July 16, 2019

Town of Paradise Valley Planning Commission
6401 East Lincoln Drive
Paradise Valley, Arizona 85253

Re: Preliminary Plat for Lavitt Manor II—Two Lot Subdivision: 7525 N. Ironwood Drive

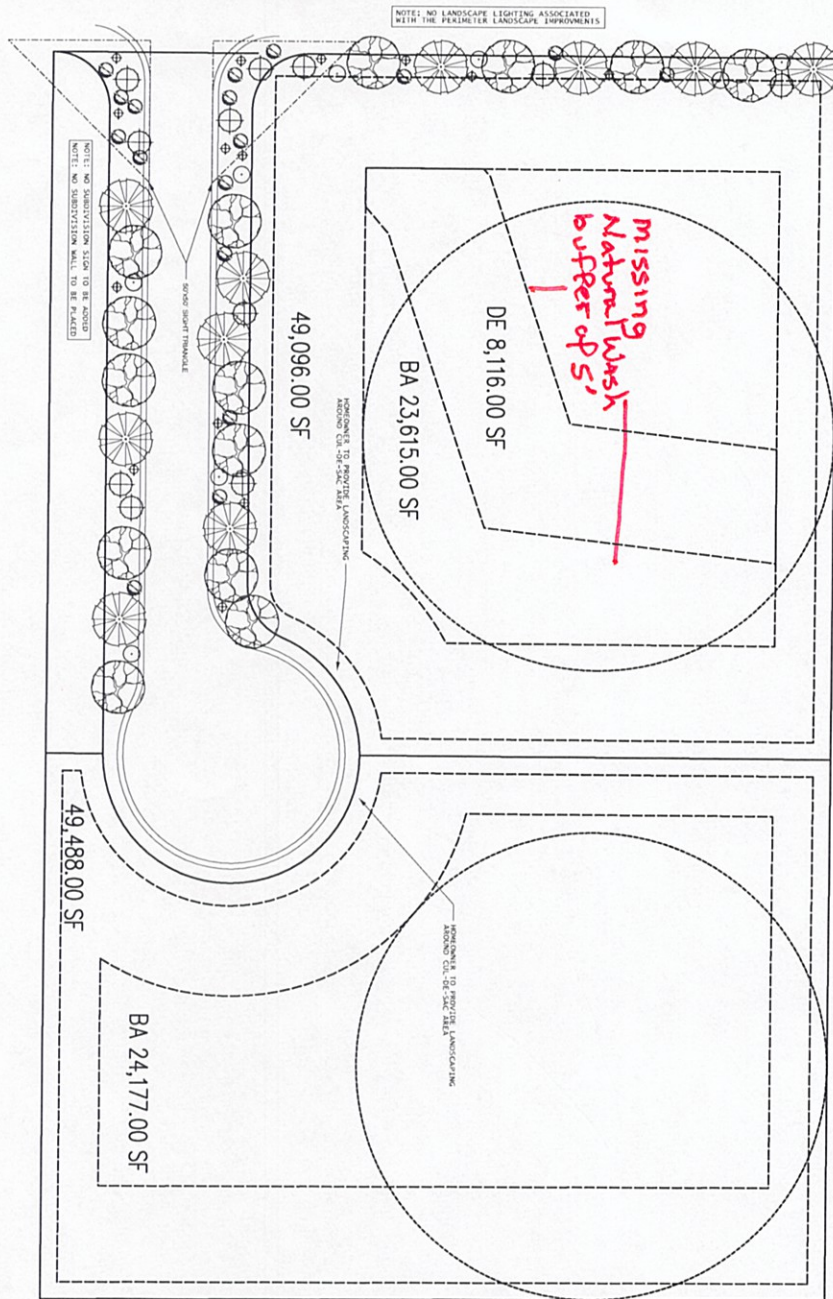
A close review of the proposed Preliminary Plat and the Paving Grading Drainage shows the five cross sections of the wash **are not** equally spaced **and not** across the entire wash (*see exhibits*); moreover, the information contained within those points selected warrant the Commission asking for further information. Point C3-6 appears in the 20 foot landscape area of the Preliminary Plat and appears to be approximately 8 feet from the beginning of the wash on the subdivision property. In contrast, point C3-10 appears to be approximately 30 feet from the end of the wash where it enters the easement created by the large Natural wash. The Storm Drainage Design Manual and the Town Code require equally spaced cross sections across the property—which the drainage cross sections provided are not. The reason for the non-equally spaced cross section points will become evident when viewed together and discussed below.

Two of the five points meet the requirements to deem the smaller wash a “Natural Wash.” However, point C3-10 is the only point that expands to the hundredth decimal position and is a mere ½ inch away from the 2.0 foot mark to make the wash a Natural Wash with an easement needing to be given to the Town to protect the wash. More importantly, look at point C3-10 on the Paving Grading Drainage Plat—point C3-10 is approximately 30 feet from where it exits into the large Natural Wash with no cross sections taken in the area (recall point C3-6 was taken only about 8 feet from the end of the wash on the south side of the property) *See exhibits*.

With the new Natural Wash and landscape buffer zone required adjacent to both Natural Washes, Lot 1 of the proposed Subdivision will be trifurcated into three separate land masses (*see exhibit*) making it difficult, if not impossible, to provide a satisfactory and desirable building site as is required to approve a new Subdivision under Paradise Valley Town Code 6-3-5(A). Once an appropriate Plat map is presented to the Commission reflecting the Natural Washes and buffer zones, it will become readily apparent the building site will not be satisfactory or desirable. Indeed, it would seem that the prior developer recognized the importance of preserving the Natural Washes and the difficulty in developing around the washes. Thus, only a single lot was developed—rather than two lots.

Does not show required Landscape Buffer here or on plat 3-6(3) Storm Drainage Design Manual
